Fwd: 20 Beach Green AWDM/1265/24

Re: Objection to Amended Planning Application AWDM/1265/24 at 20 Beach Green

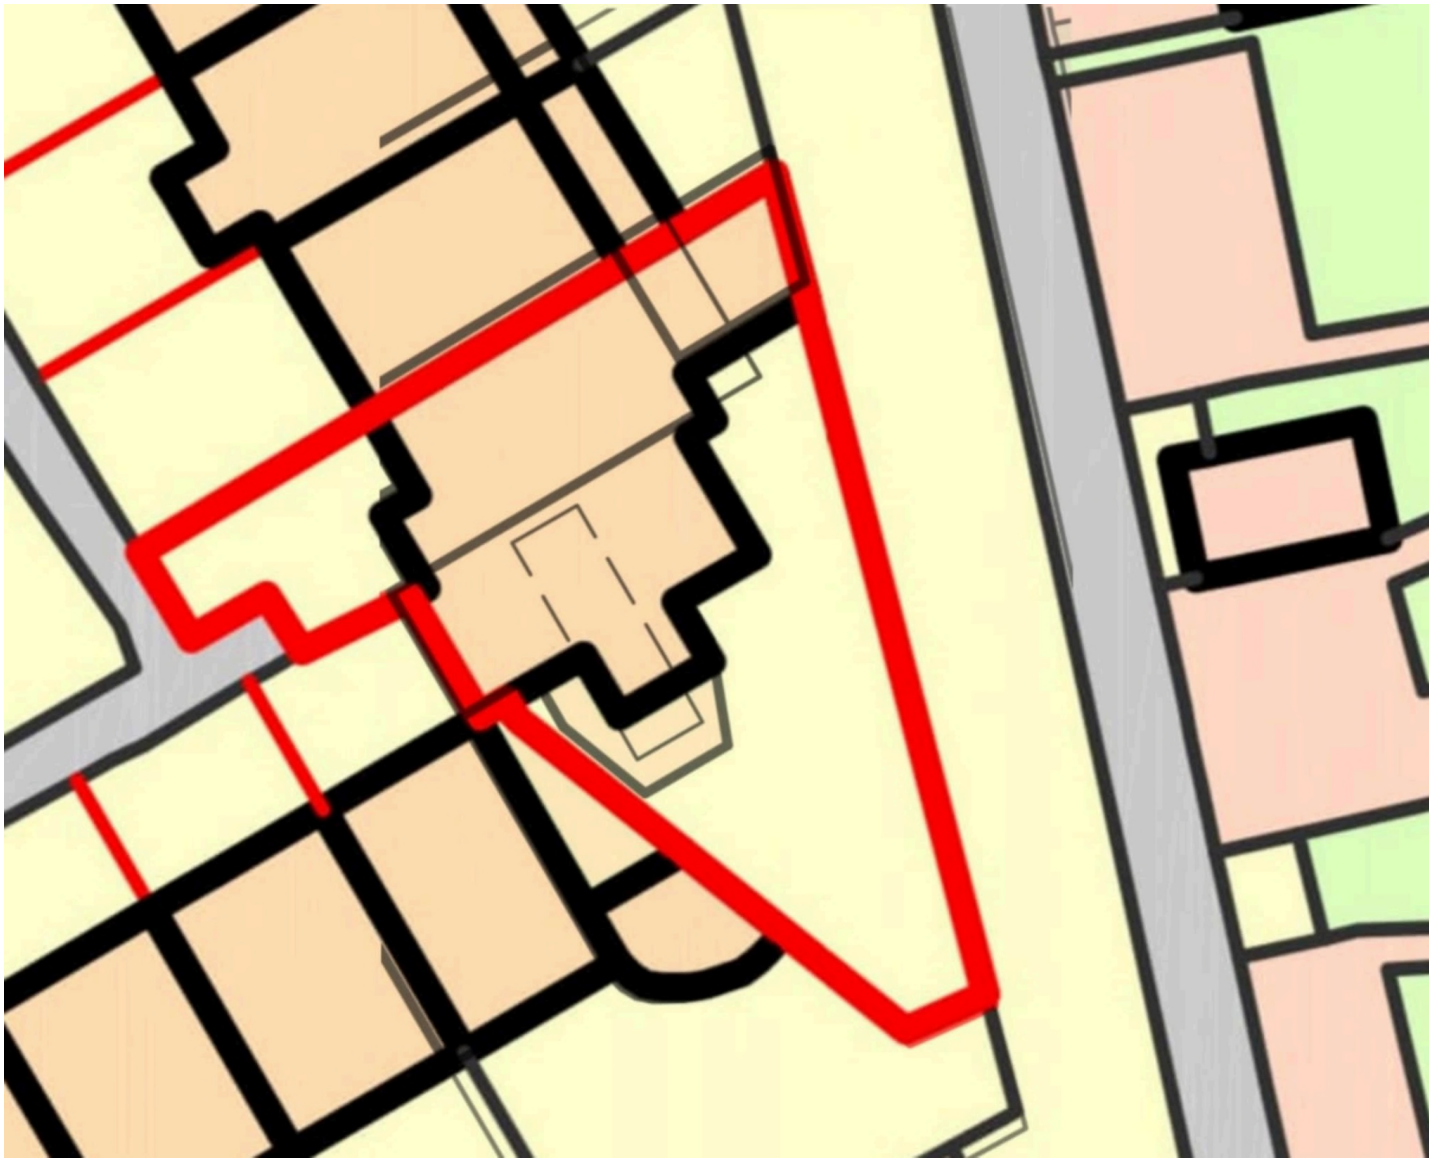
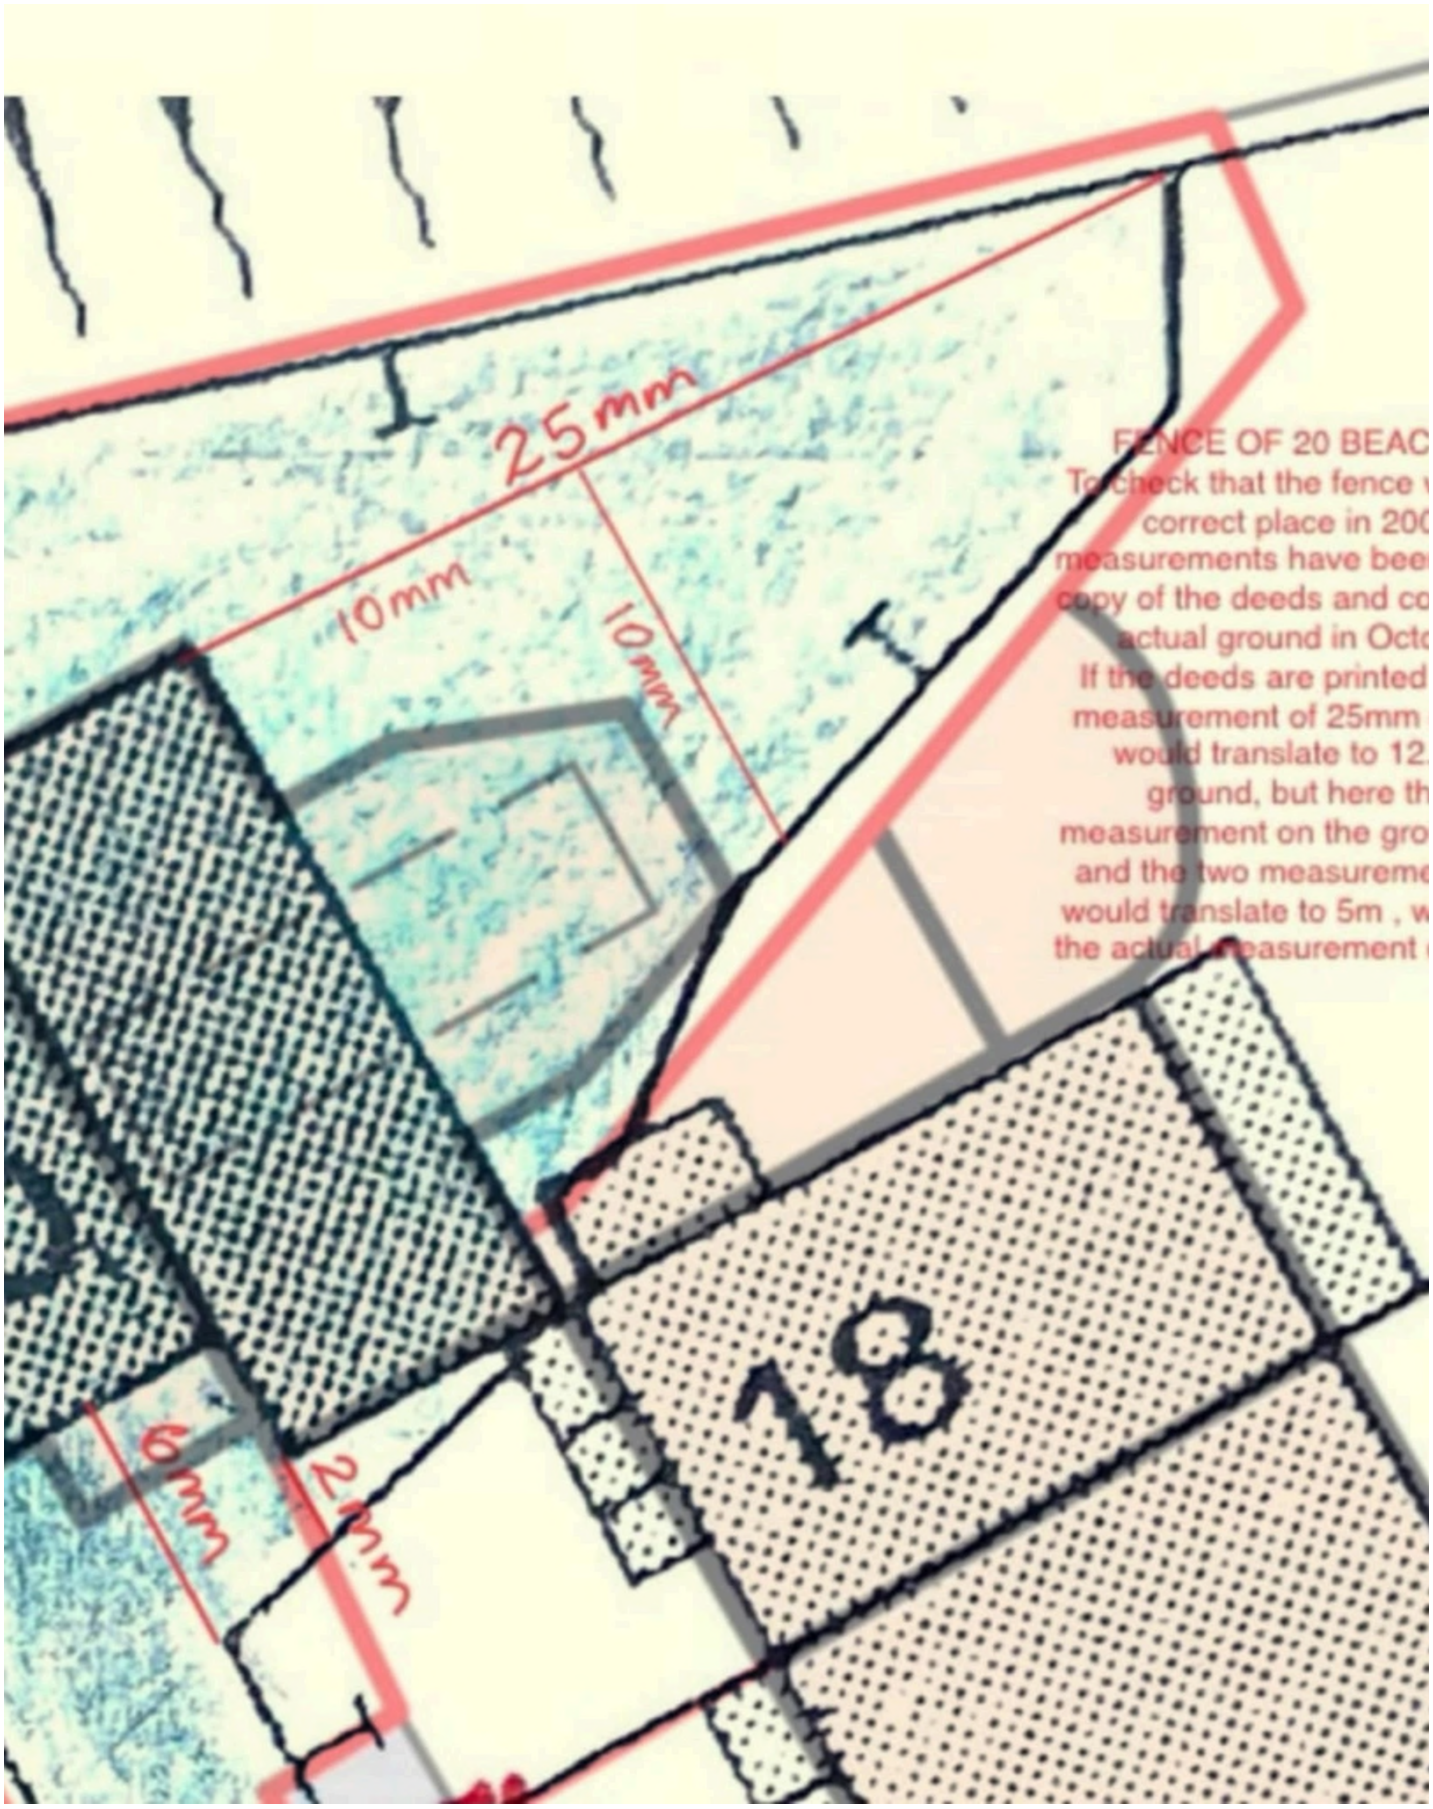
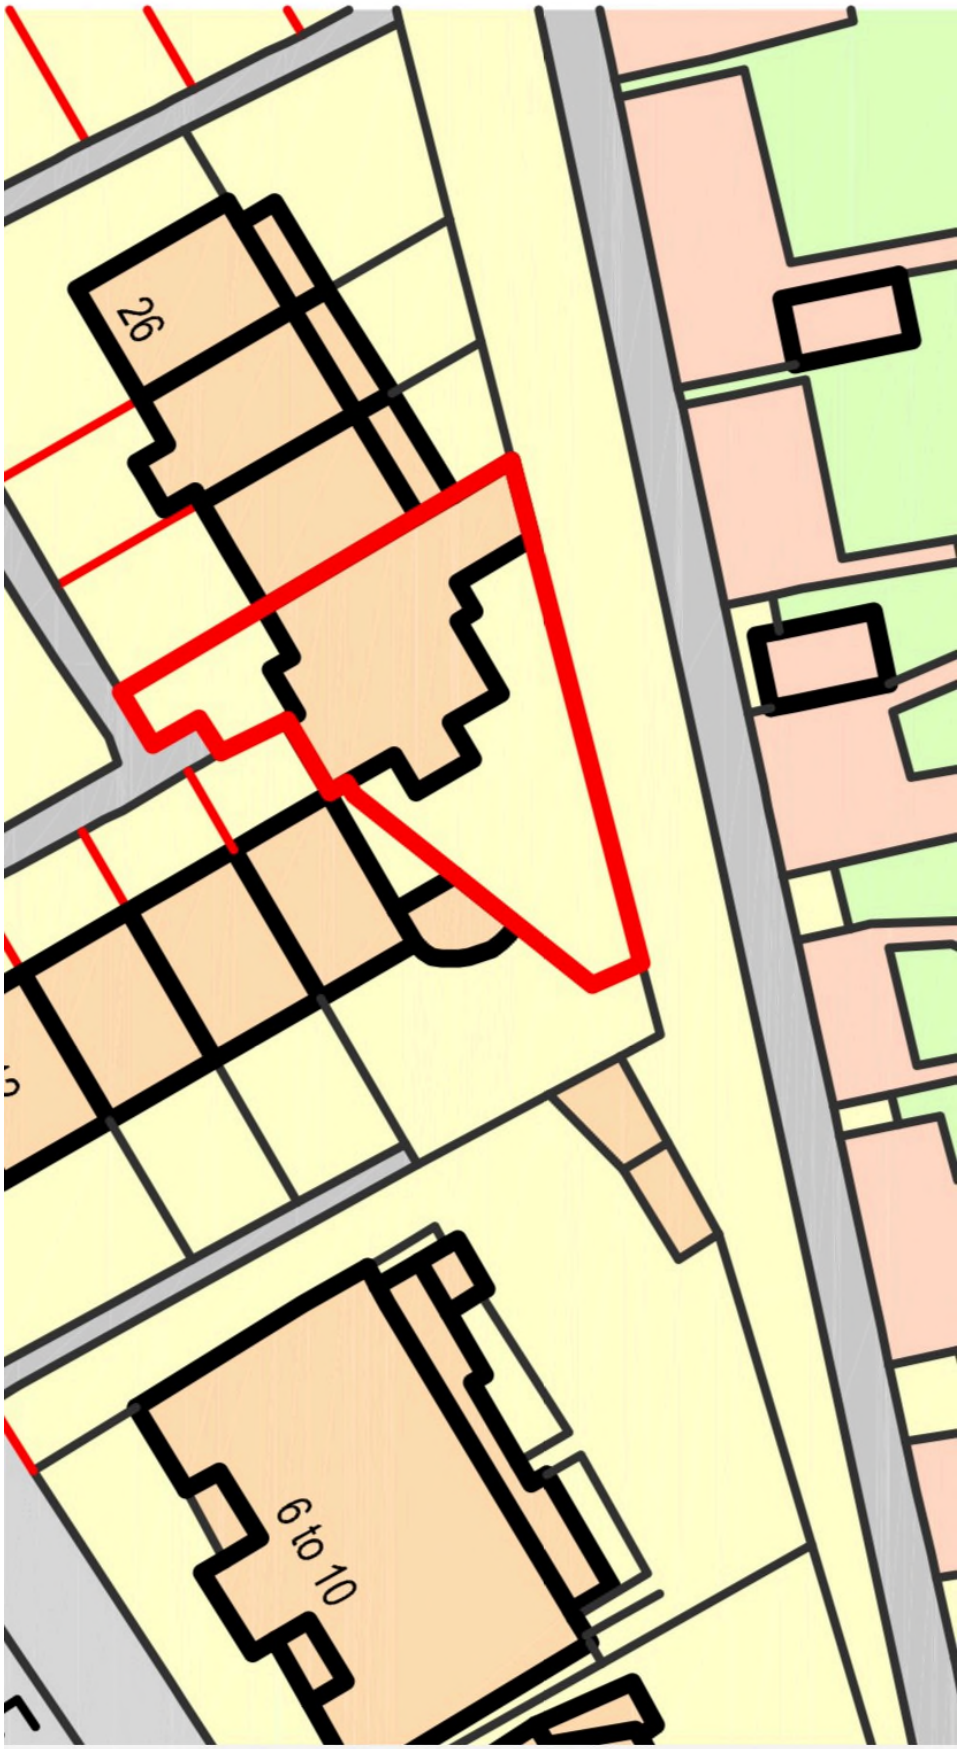
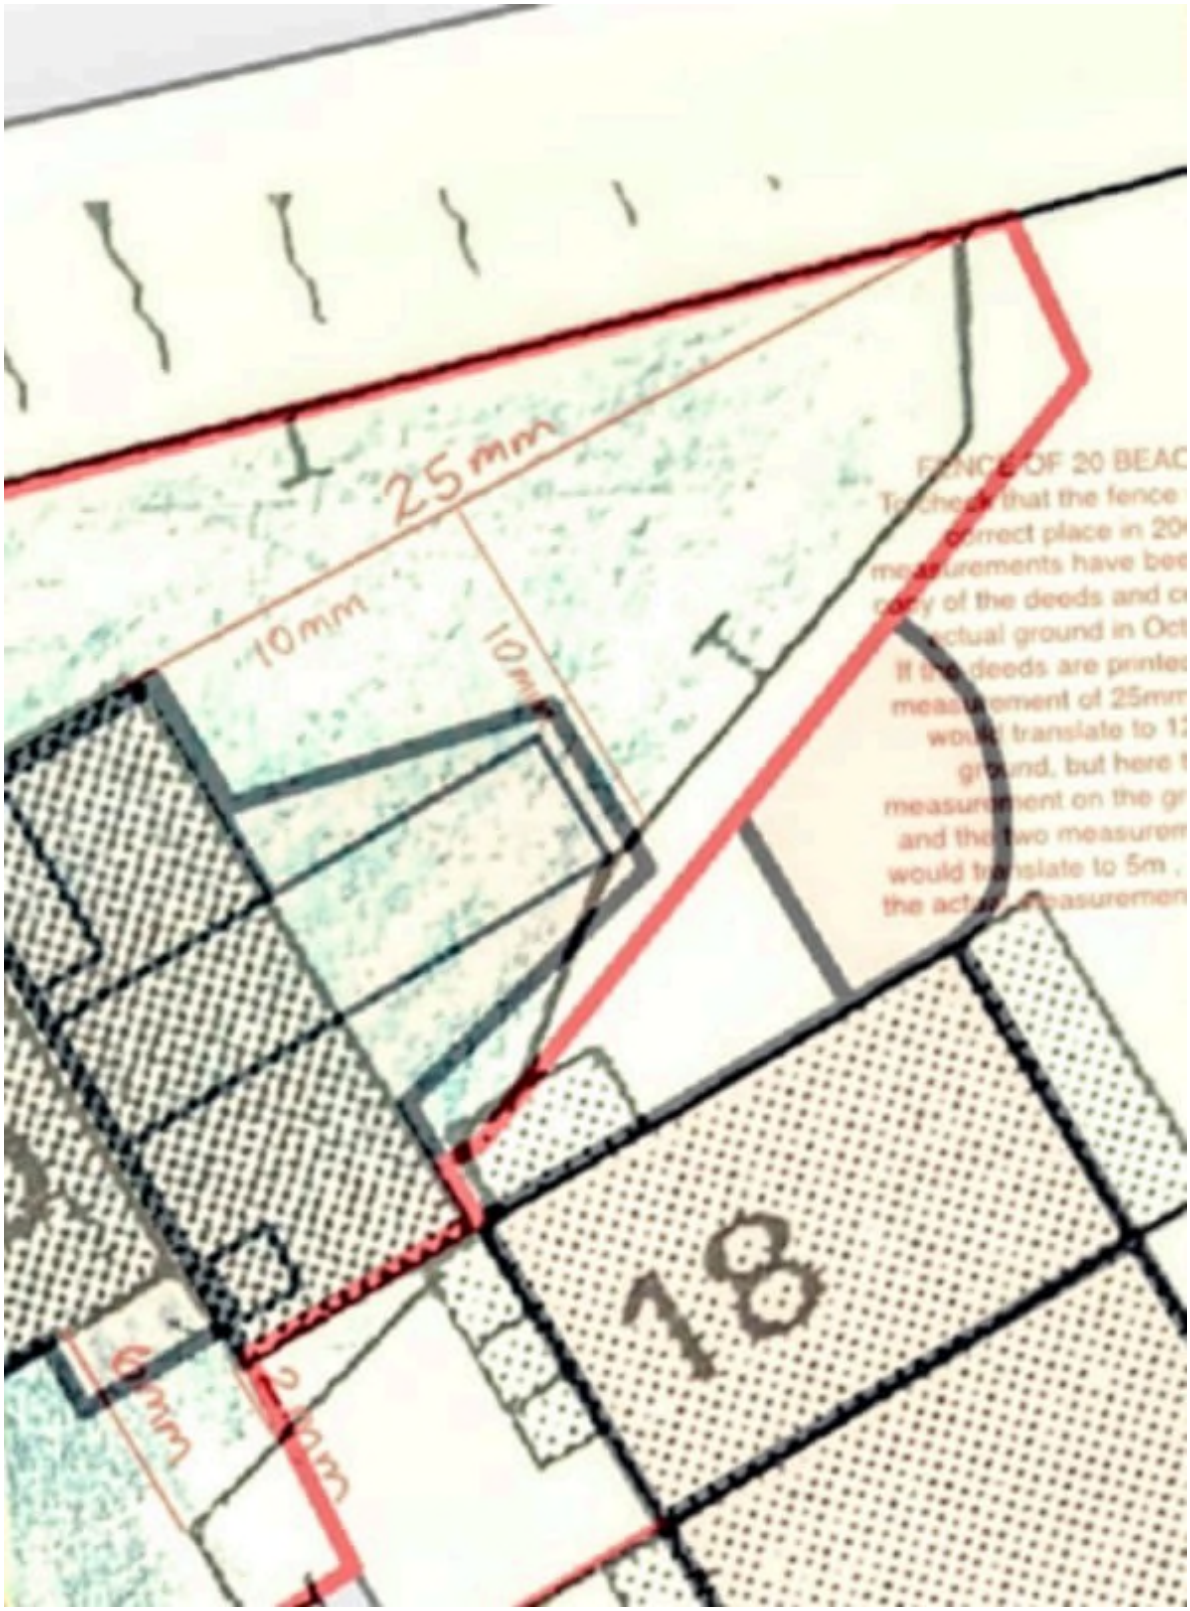
To illustrate the inconsistent boundary depiction, I have prepared two overlays:

• Overlay A: Land Registry vs. Architect's Drawing

• Overlay B: Ordnance Survey Map vs. Architect's Plan

The added pictures are the original architect revised drawings and is report showing differing placement of extension outer wall compared to overlay B
